PROJECT : Z01

COVER SHEET 1 OF 1

MB ASSY'S P/N : 31Z01MB00XX

Size	Document Number	Rev
	<b>PC8769L &amp; FLASH</b>	3B
Date:	Thursday, May 17, 2007	Sheet 20 of 26

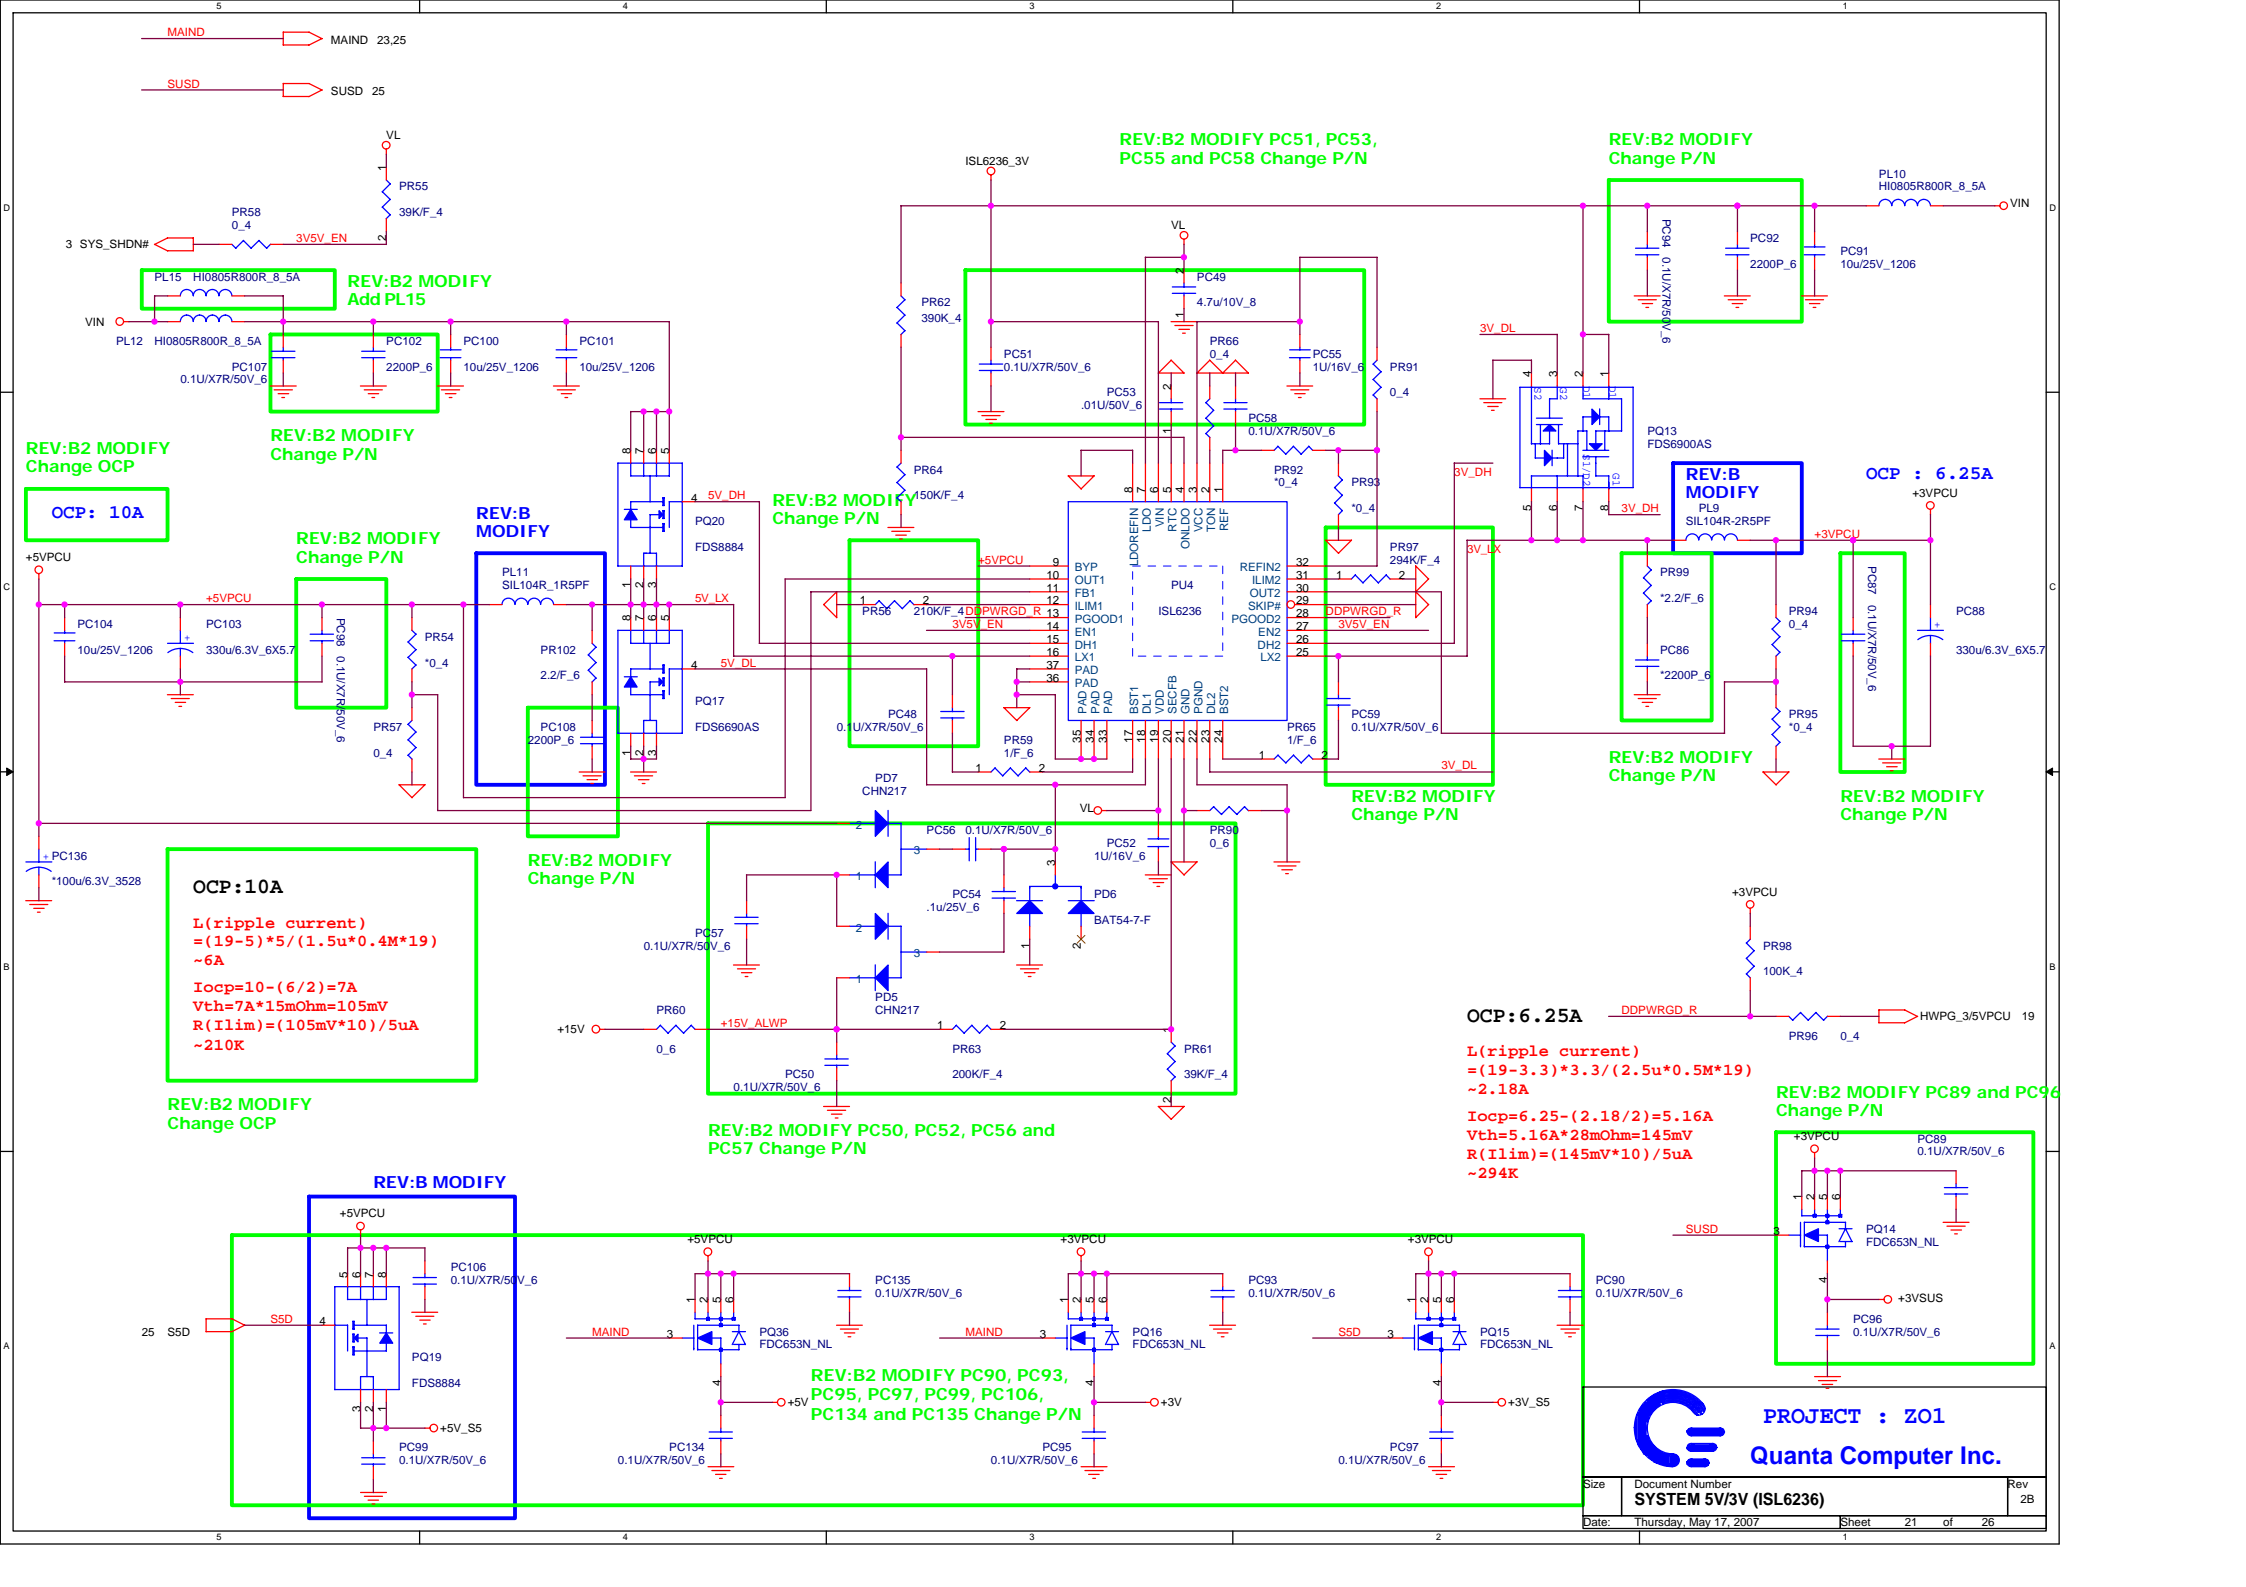
08/10 FAE:  
L83 CAN CHANGE FROM BEAD TO SHORT.  
BUT, PLEASE PUT AGND & 32K CAP & AVCC CAP AT ONE POINT.  
ZS1 STILL USE BEAD FOR SAFE.

1/13 Confirm by vendor mail:  
Disabled (1) if using FWH device on LPC.  
Enabled (0) if using SPI flash for both system BIOS and EC firmware

1/13 Confirm by vendor mail:  
If the Southbridge enables 'Long Wait Abort' by default, the flash device should be 50MHz (or faster)

Size	Document Number	Rev
	<b>CHARGER (ISL6251A)</b>	3A
Date:	Thursday, May 17, 2007	Sheet 25 of 26

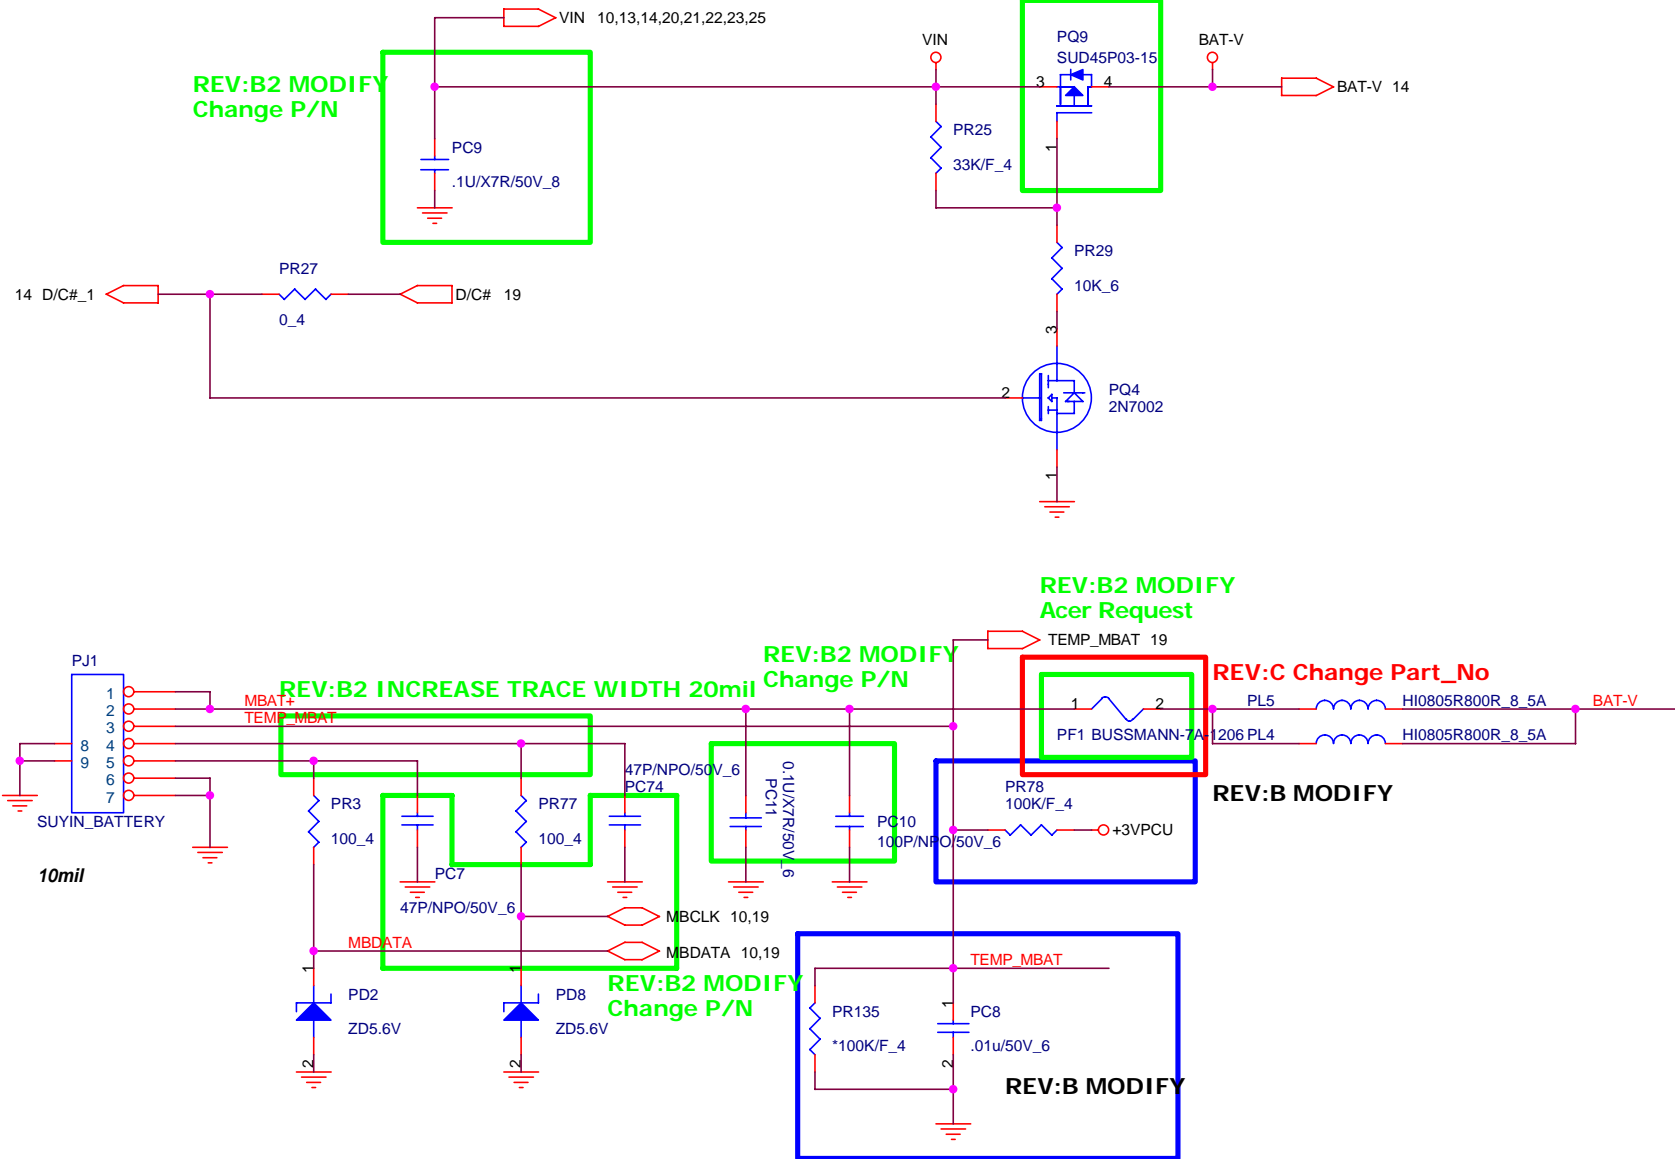
**REV:B2 MODIFY Change OCP**

**REV:B2 MODIFY Change OCP**

**REV:B2 MODIFY PC51, PC53, PC55 and PC58 Change P/N**

**REV:B2 MODIFY Change P/N**

**REV:B2 MODIFY Change P/N**

**REV:B2 MODIFY PC50, PC52, PC56 and PC57 Change P/N**

**REV:B2 MODIFY PC89 and PC96 Change P/N**

**REV:B2 MODIFY PC90, PC93, PC95, PC97, PC98, PC106, PC134 and PC135 Change P/N**

**OCP: 10A**

$L(\text{ripple current}) = (19-5) * 5 / (1.5\mu * 0.4M * 19) \sim 6A$

$I_{ocp} = 10 - (6/2) = 7A$

$V_{th} = 7A * 15m\Omega = 105mV$

$R(I_{Lim}) = (105mV * 10) / 5\mu A \sim 210K$

**OCP: 6.25A**

$L(\text{ripple current}) = (19-3.3) * 3.3 / (2.5\mu * 0.5M * 19) \sim 2.18A$

$I_{ocp} = 6.25 - (2.18/2) = 5.16A$

$V_{th} = 5.16A * 28m\Omega = 145mV$

$R(I_{Lim}) = (145mV * 10) / 5\mu A \sim 294K$
